STAFF REPORT

Site Plan Review (Type III)

APPLICANT: Tim Novotny, Bay Cities Ambulance
3505 Ocean Boulevard, Coos Bay, OR 97420

SUBJECT: **SITE PLAN REVIEW APPLICATION #187-19-089**
**Proposed two-story 8,870 square foot addition, for office, light storage,
and indoor parking garage uses.**

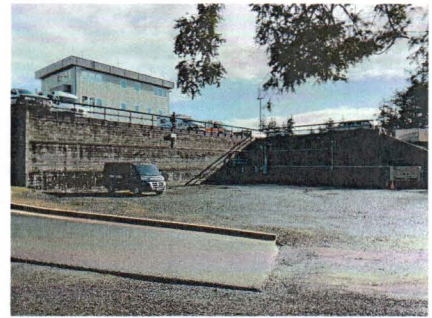
3E Landscape standards are outlined in CBMC 17.335.060 Landscaping. The existing landscaping and existing vegetation along the property boundaries of the property, provides the required 15 percent landscaping. The existing landscaping is flexible and take advantage of natural features and addresses the use and function of the use and function of the development.

The existing landscape areas provide an attractive variety in tree and shrub species, texture, color, height and density. Existing vegetation provides mature evergreen foliage that provide screening between the abutting property to the south, southeast and southwest.

The proposed new parking lots are not along a public road of way, but are setback along the south property line.

CONCLUSION: There is adequate existing landscape areas and native vegetation provided to satisfy the standards outlined in 17.335.060 Landscaping; Therefore, the criterion has been satisfied, subject to the following Condition:

Maintenance of landscaped areas is the ongoing responsibility of the property owner. Required landscaping must be continuously maintained in a healthy manner. Plants that die must be replaced with in-kind materials unless otherwise authorized by the review authority. Vegetation shall be controlled by pruning, trimming or otherwise so that it will not interfere with the maintenance or repair of any public utility, restrict pedestrian or vehicular access, or obstruct sight distance at intersections.

SITE PLAN APPLICATION EXISTING/PROPOSED UTILITIES PLAN

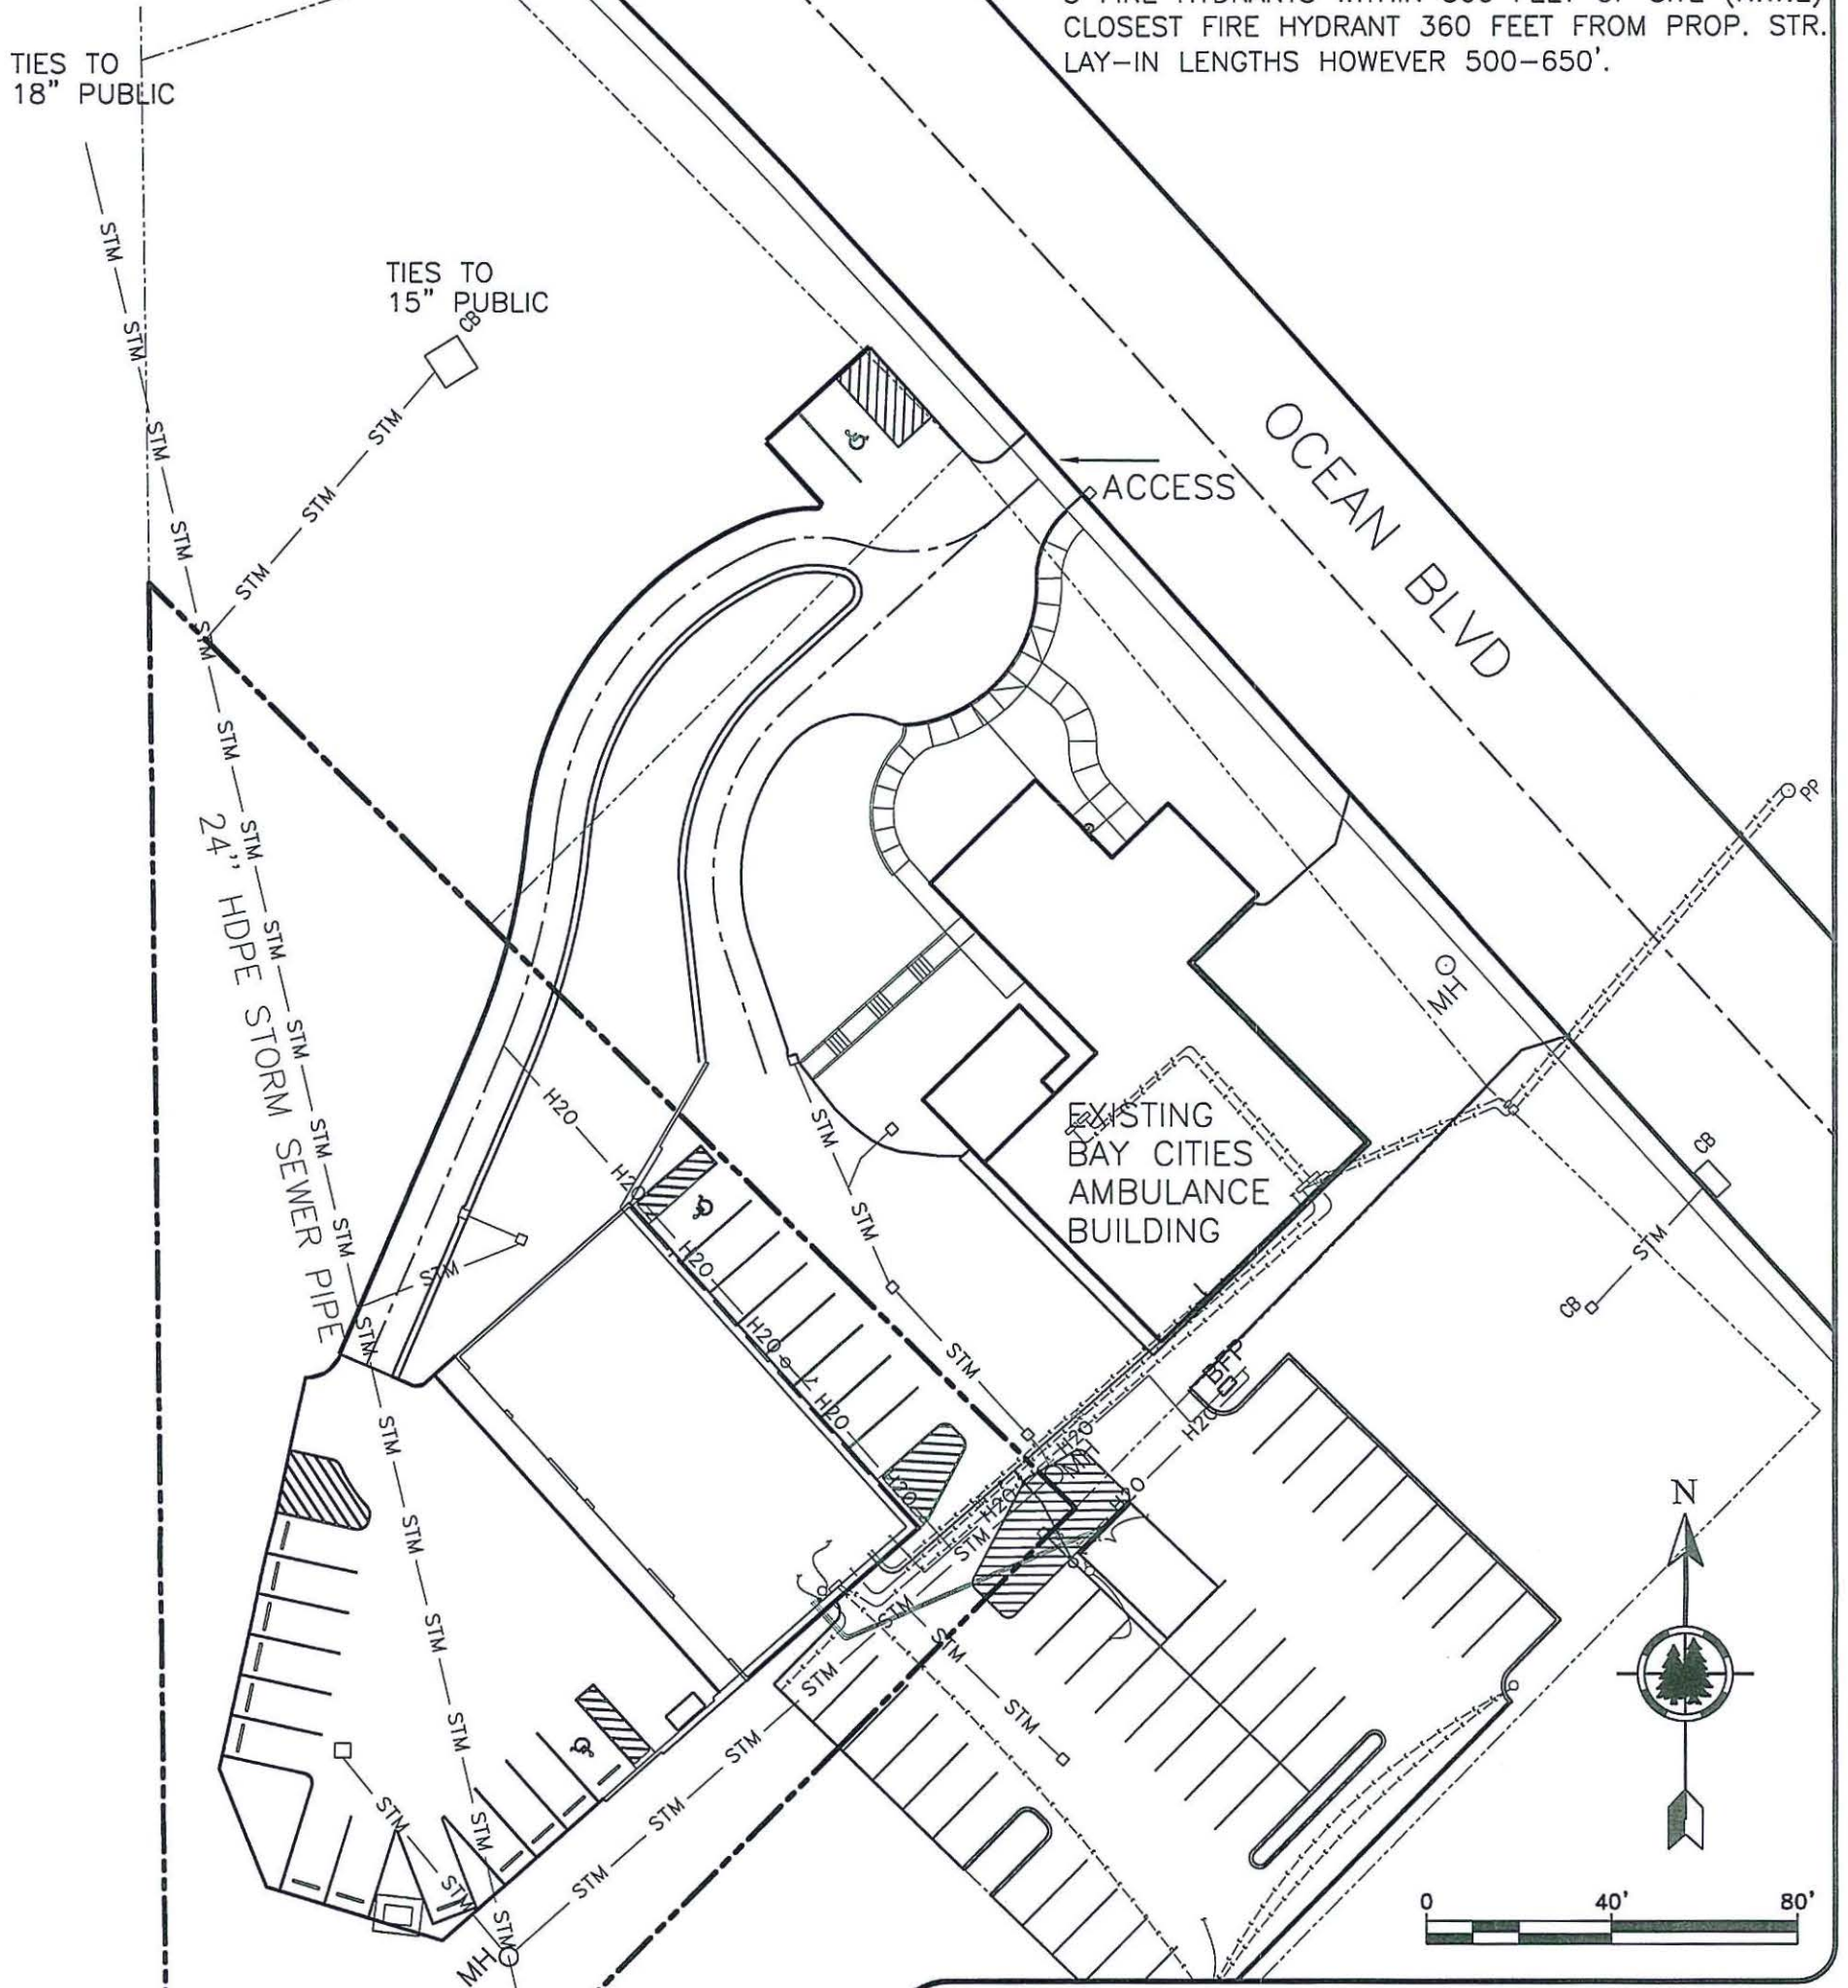
Private sanitary sewer shall be installed to the City of Coos Bay Municipal Code (CBMC) and standards and in accordance with the approved specifications. And submitted to city for review prior to permit issuance.

Portions of the downstream Sanitary Sewer system, in which the project is tying into, has been identified in the City's Sewer Master Plan as being deficient. To allow a connection to the system the applicant can provide a "payment in lieu". The payment will be based on the Equivalent Dwelling Units (EDU's) methodology already established in the 2006 City report titled, Wastewater Collection and Storm Drainage System Development Charge Study.

7. Submit for approval calculation of equivalent dwelling units (EDU) for review and approval. Calculation must be based on methodology already established in the 2006 City report titled, "Wastewater Collection and Storm Drainage System Development Charge Study" and must be prepared by a licensed engineer.

SITE PLAN APPLICATION PROPOSED IMPROVEMENTS PLAN

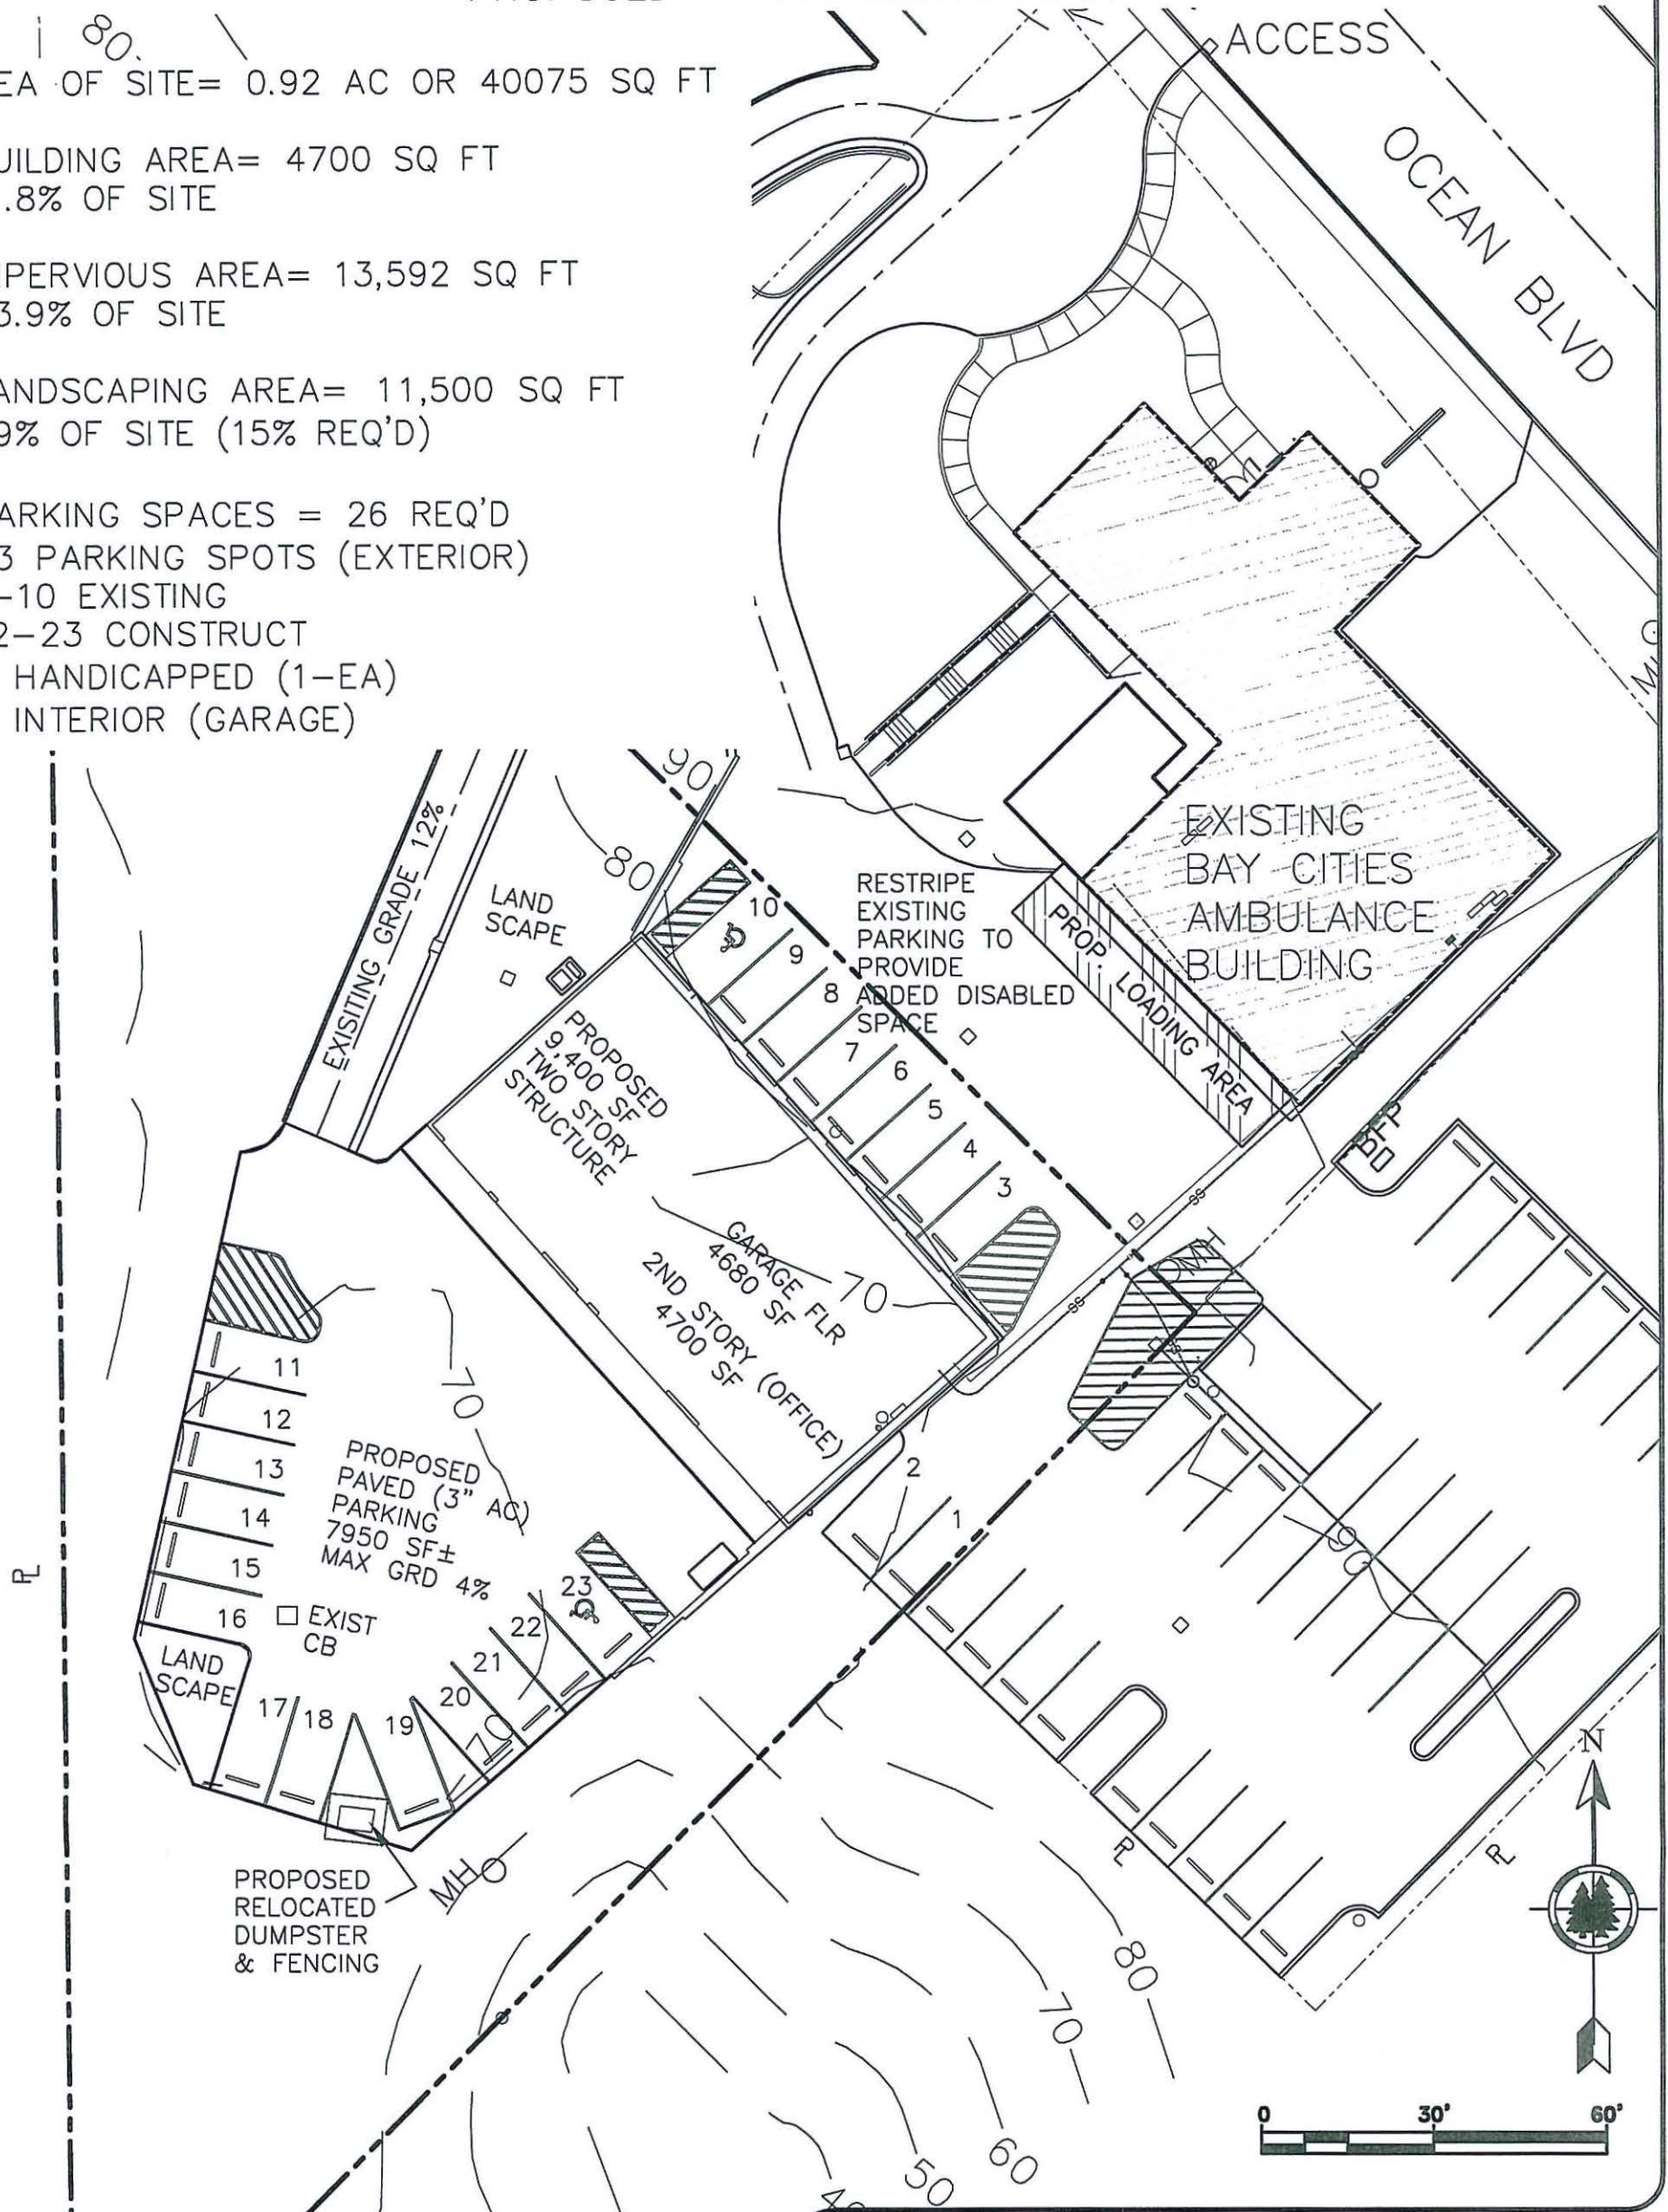
- 4A. There are 44 existing off-street parking spaces. The proposed development will include 13 off-street parking spaces south of the proposed structure for a total of 57 off-street parking space, including three ADA compliant spaces/aisles.

- 5A. A Public Works "Site Development Permit" is required in preparing the property for development. Temporary erosion control measures are necessary and shall be in place for the duration of any site work and/or development.
- 5B. Comments from the City of Coos Bay Fire Department were as follows: Fire service access road must meet Oregon Fire Code for width (20 feet), grade (<10%), surface (paved), and length (over 150 long requires an approved turn-around).

The project must submit updated stormwater analyses that follows the City's current hydrologic and hydraulic criteria prior to structural permit issuance. Additionally, the project shall incorporate onsite detention facilities that not only account for increased volume due to the proposed project but also the duration of the flows (it appears that current analysis only accounts for volume). By updating either the hydrologic methodology or the detention analysis this may cause the detention basin to be larger than what is currently shown on the plans and thus applicant will be responsible to revise the site plan accordingly.

Additionally, on the site plan submitted with the land use application it was not clear as to where the water quality feature is proposed. This must also be clarified along with updated calculations to be submitted prior to structural permit issuance. CBMC 18.20 states: "Plans for permanent stormwater management shall be provided for every street improvement and land development proposal that disturb 1,000 square feet or more". Permanent water quality features will be required for this project. This can include but is not limited to bioswales, rain gardens, porous pavement, etc. Post construction Water Quality measures must be installed onsite and maintained into perpetuity.

It is not apparent where the Post Construction Water Quality measures is located nor are there any details to the how it will be constructed. Prior to permit issuance the applicant shall submit plans reflecting the location and details of the permanent water quality feature. Applicant must submit for review and approval an inspection and maintenance procedure manual for the permanent water quality features. Once approved, these procedures will be recorded with a Declaration.

3. Revised access plans must be submitted that verifies compliance with Fire Code requirements, including the fire service access road must meet Oregon Fire Code for width (20 feet), grade (<10%), surface (paved), and length (over 150 long requires an approved turn-around).

4. The applicant shall update the storm water analysis that not only evaluates the increased volume but also the duration of the flows. By updating either the hydrologic methodology or the detention analysis this may cause the detention basin to be larger than what is currently shown on the plans and thus applicant will be responsible to revise the site plan accordingly. Additionally, on the site plan submitted with the land use application it was not clear as to where the water quality feature is proposed. This must also be clarified along with updated calculations to be submitted prior to structural permit issuance.

5. The applicant shall submit plans reflecting the location and details of the permanent water quality feature.
6. Post Construction Water Quality measures must be installed onsite and maintained into perpetuity. Applicant must submit for review and approval an inspection and maintenance procedure manual for the permanent water quality features. Once approved, these procedures will be recorded with a Declaration. The City will prepare the Declaration and the owner will be responsible for recording fees. Design and manual for the permanent storm water control do not need to be included with land use applications but will be required.
